December 14, 2007
Project No.: 015-01-031

Subject: Revised Work Plan for Further Site Characterization for Fuel Leak Case No. RO0000324, Livermore Gas and Mini-Mart, 160 Holmes Street, Livermore, California

APPENDIX A
ACEH's November 9, 2007 Letter

Subject: Fuel Leak Case No. RO0000324 and Geotracker Global ID T0600102287, Livermore Gas and Mini-mart, 160 Holmes Street, Livermore, CA 94553

Sheet Name and Address
BORING LOCATION PLAN
 160 HOLMES STREET
 LIVERMORE, CALIFORNIA

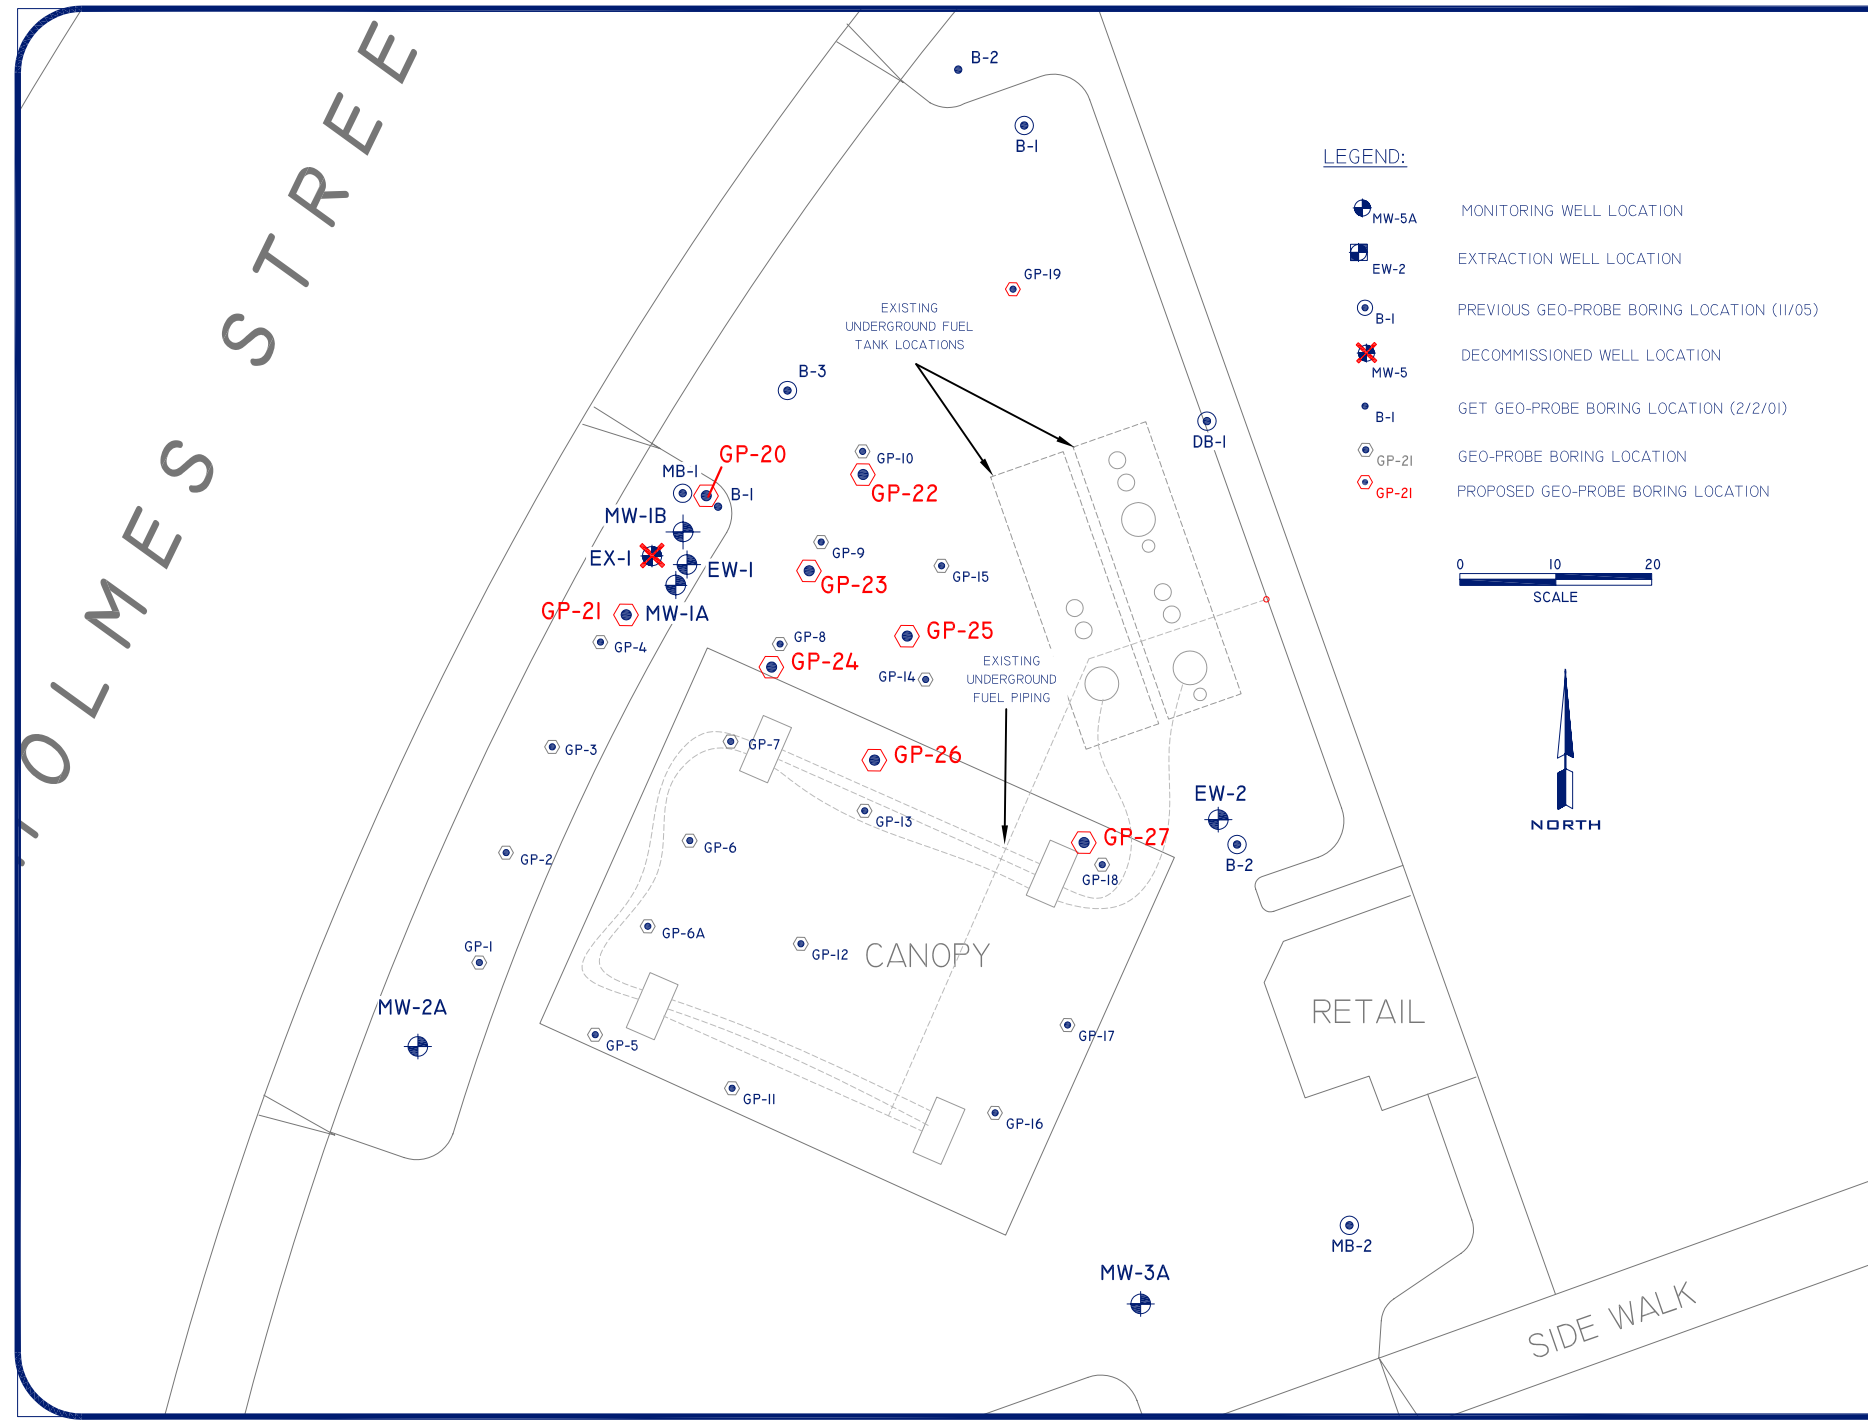
2. **Proposed Well Clusters.** We concur with the proposed locations of well clusters MW-8 and MW-9. We do not concur with the proposal to install well cluster MW-10 adjacent to the location of previous boring DB-5. A grab groundwater sample collected from boring DB-5 on November 10, 2001 did not contain detectable concentrations of TPHg, BTEX, or fuel oxygenates. Therefore, the purpose of proposed well cluster MW-10 is not clear. Please

delete well cluster MW-10 or provide additional rationale regarding the need for well cluster MW-10.

ACEH concurs with the proposed locations of well clusters MW-8 and MW-9. ACEH also requested additional rationale for installing the proposed MW-10 well cluster.

Rationale for MW-10 Well Cluster: The existing monitoring well network at the Site does not have a monitoring point in the cross-gradient direction to the north. Currently, boring DB-5, installed in 2005, is the only data point available for providing cross-gradient characterization of the hydrocarbon plume. Additionally, the groundwater sample collected from DB-5 was limited to the A-Zone only. If a well cluster were to be installed adjacent to previous boring DB-5, the Site's monitoring well network would have improved groundwater gradient data and continuous evaluation of groundwater quality north of the Site.

However, Allterra recommends that a MW-10 well cluster not be installed at this time. Installation of a MW-10 well cluster should be revisited at a later date after the current investigation is complete and an evaluation of groundwater conditions has been performed.
